610.18313-L01-v0.1 20210208.docx

90-102 Regent Street, Redfern Wind Impact Assessment Awning Design and Wind Load Issues

Figure 1: Proposed Façade Articulation

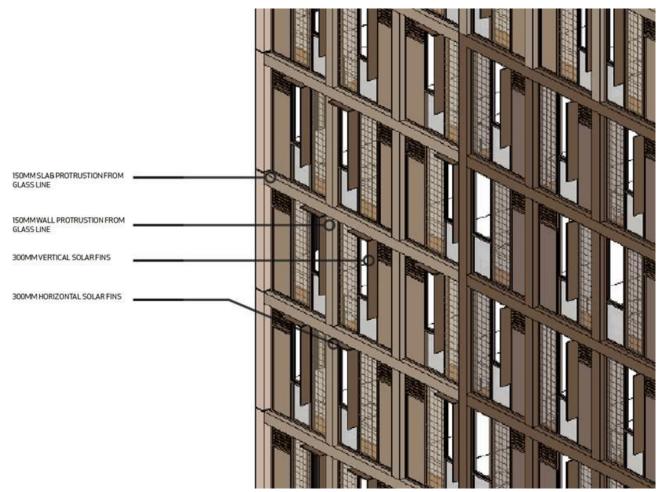
- There is a suggestion that the façade design should be amended to limit wind effects and downwash to common open spaces. It is noted that the current façades are articulated and incorporate several changes to reduce wind loads:
 - Each level of the tower façade includes 150mm wall and slab edge protrusions
 - Half of the facades, particularly at high level include vertical and horizontal solar fins, further mitigating downdraft winds.

- Additional modifications to façade design can produce changes to windflow patterns around high-rise buildings when going from a flat, curtain wall form to a highly articulated, stepped façade form. In some case, windflow patterns merely shift and the resulting "hot spots" merely move their location (compared to the curtain wall baseline). Moreover, the available literature on such effects are limited and involve significant changes to the façade form.

- Any additional design change to the façade of the proposed development will have questionable impact on winds below (and my indeed simply move any wind hot spots elsewhere).
